**PLANNING COMMISSION
STAFF REPORT
AGENDA ITEM NO. 6.A.
March 17, 2015**

Request for an Architectural Review Permit for the construction of ten individual replacement single-family dwellings on ten pre-existing lots within the Crestmoor neighborhood per the Development Agreement adopted by the City Council on January 27, 2015. City of San Bruno & PG&E (Property Owners), Castle Companies, Inc. (Applicant).

Staff recommends the Planning Commission approve Architectural Review Permit 15-001, based on Findings of Fact 1-5 and Conditions of Approval 1-52.

L-4

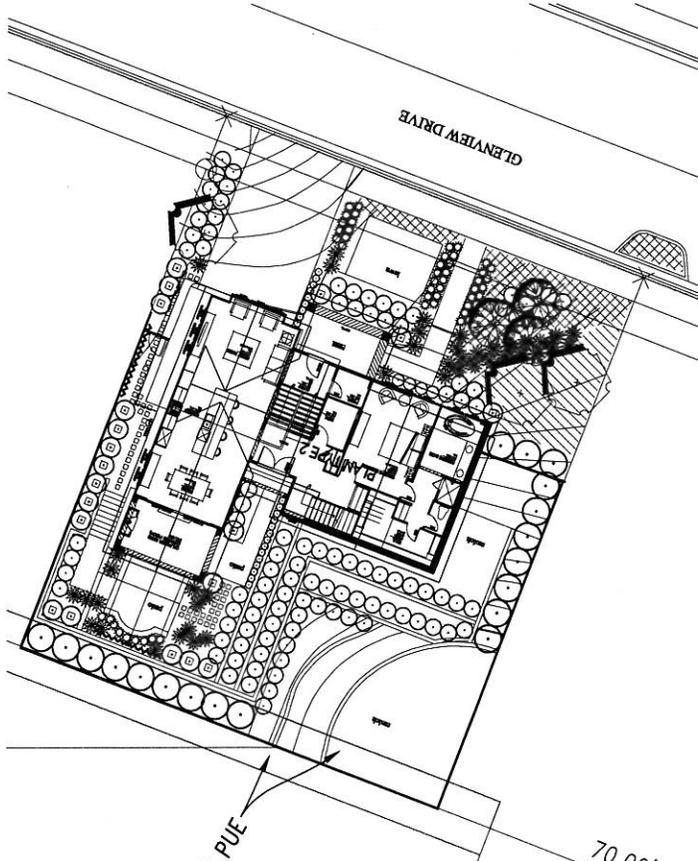
- All landscaped areas shall contain a ground cover, including mulch.
- Each lot shall utilize different landscaping treatment measures to ensure aesthetic variety among the various lots.

NOTE: EACH LOT SHALL UTILIZE DIFFERENT LANDSCAPING TREATMENT MEASURES TO ENSURE AESTHETIC VARIETY AMONG THE VARIOUS LOTS

PRELIMINARY FENCING PLANS
CRESTMoor

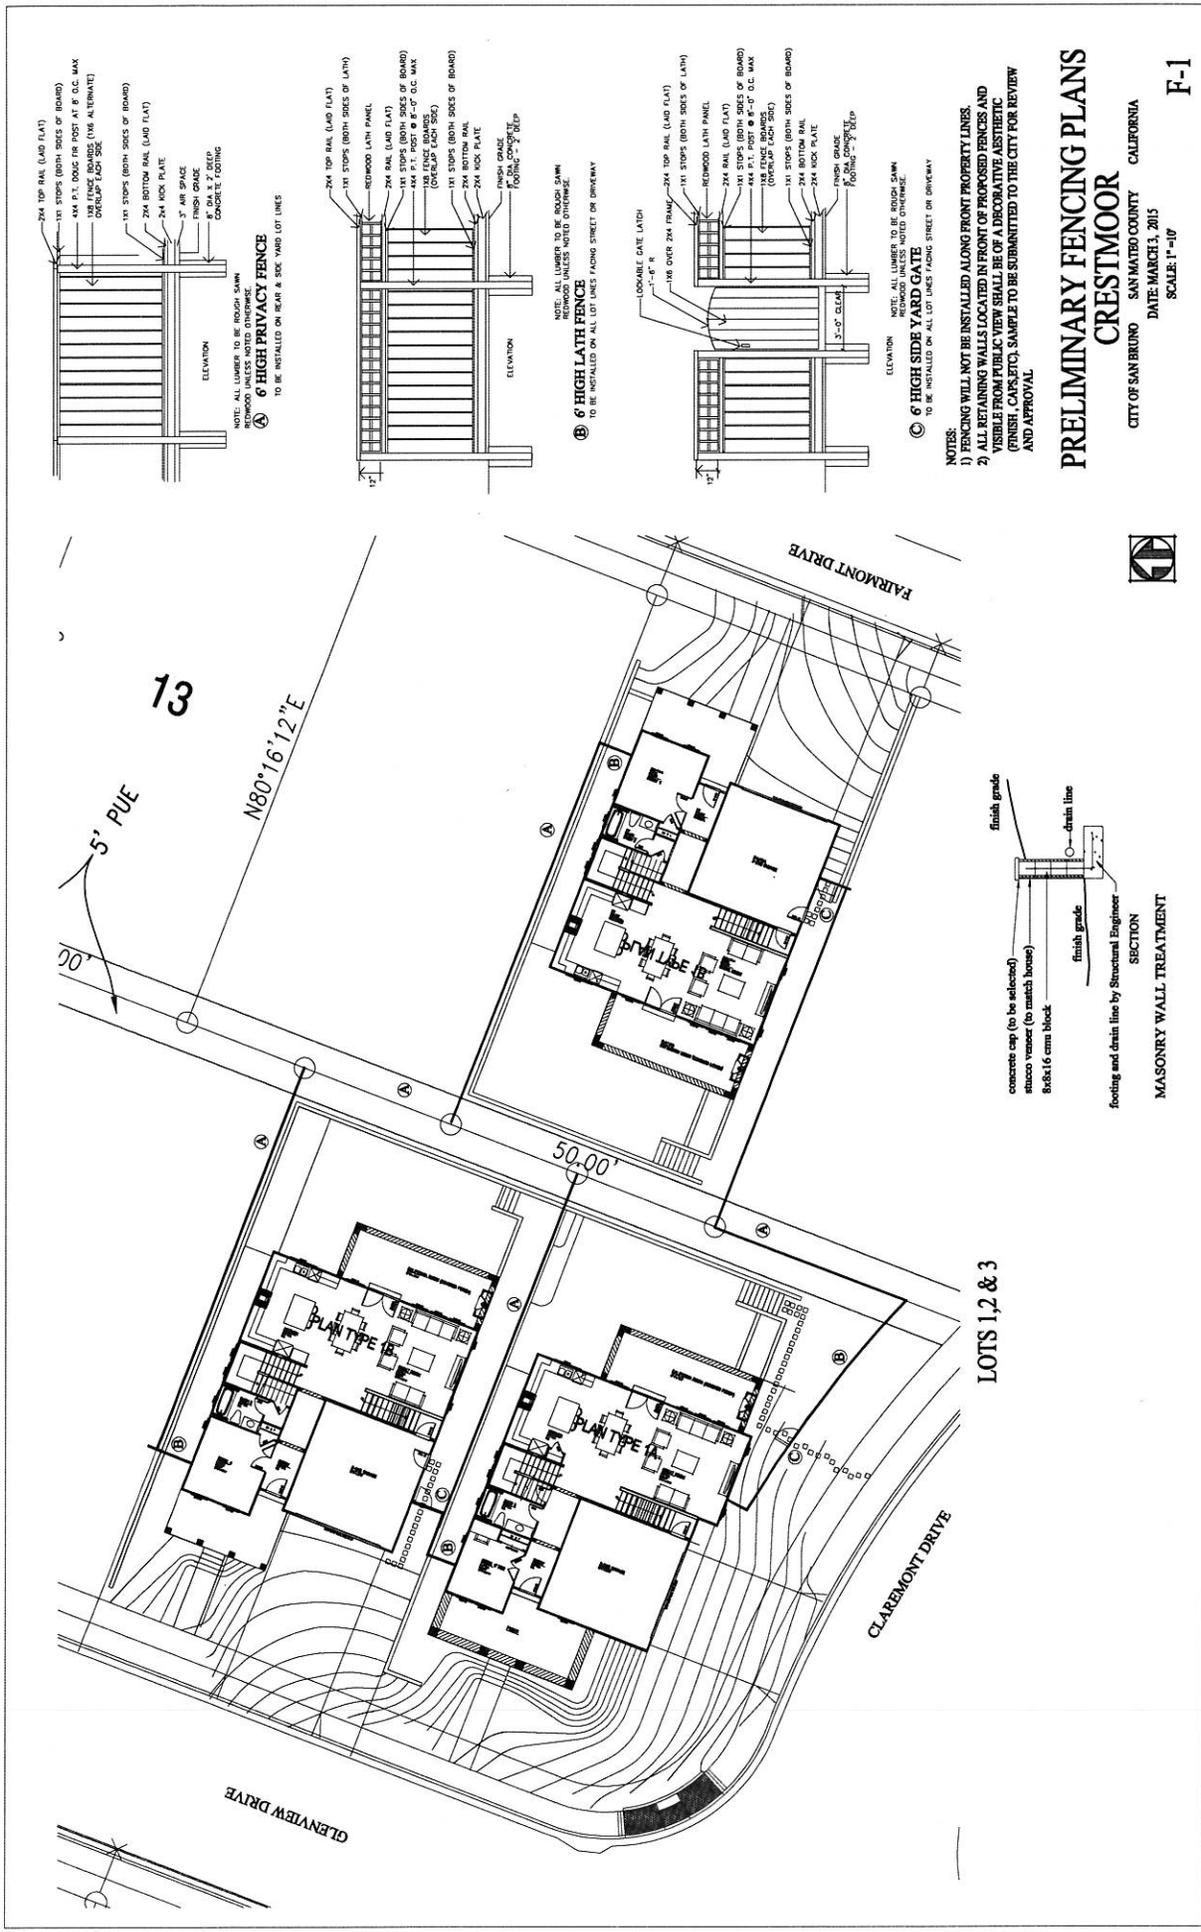
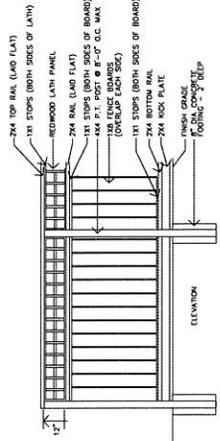
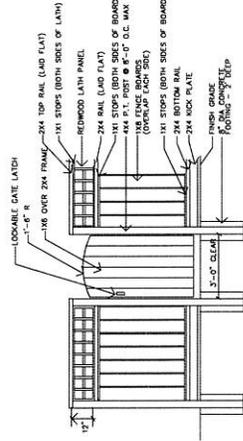
A 6'-0" fence is proposed along all side and rear lot lines for all ten lots. Staff included condition of approval #16 requiring the following note within the fencing plans to be removed: "To be installed on all lot lines facing street or driveway." This condition of approval was included to clarify that the proposed fencing would not be installed on the front property line.

15. The stairs providing access to the porch located on Lot #4 shall be located at least 9'-0" from the front property line.
16. At the time of building permit submittal, the following note on the fencing plans shall be removed: "To be installed on all lot lines facing street or driveway." Fencing shall be installed at locations as indicated on approved plans.
